From: Tai, Tom
Sent: Tuesday, August 07, 2012 4:26 PM
To: Chappell, Coley; Tomkins, James
Cc: STPCOL
Subject: FW: Downstream Fuel Effects Tests
Attachments: Chapter 6 Followup Presentation JUNE Action Items Only- NRC.pdf

Tom-----The proposed wording on Slide 35 is different than in COLA Rev.7, App. 6C (although similar). My question is.....is the Rev.7 wording the final version?

South Texas Project Units 3 & 4 Presentation to ACRS Subcommittee Chapter 6 Follow-up

Hot Assembly Flow vs. Blockage Factor

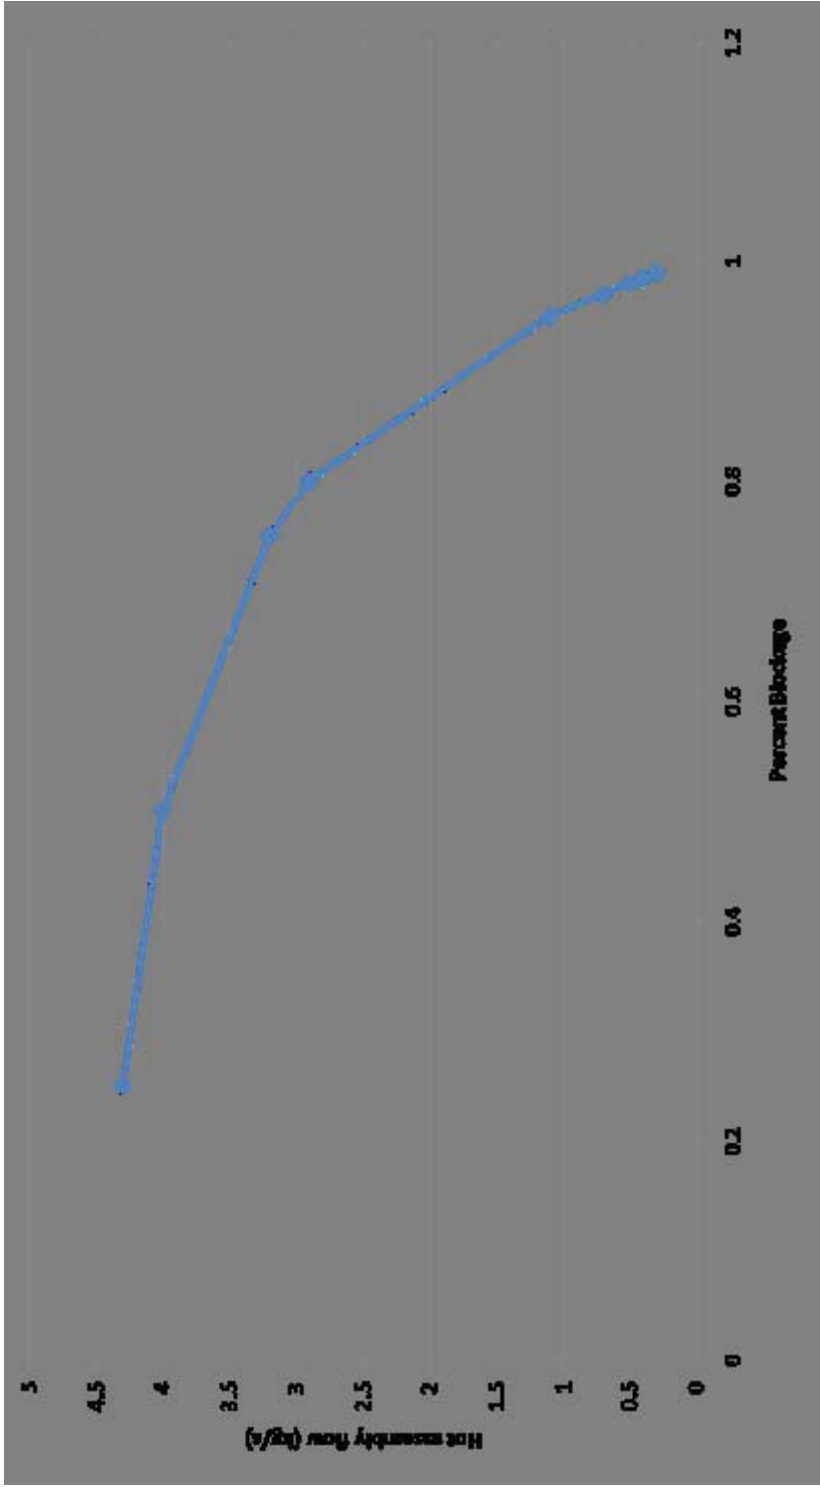
- Action Item # 84
- *ACRS requested a parametric study of k-factor vs. flow rate*
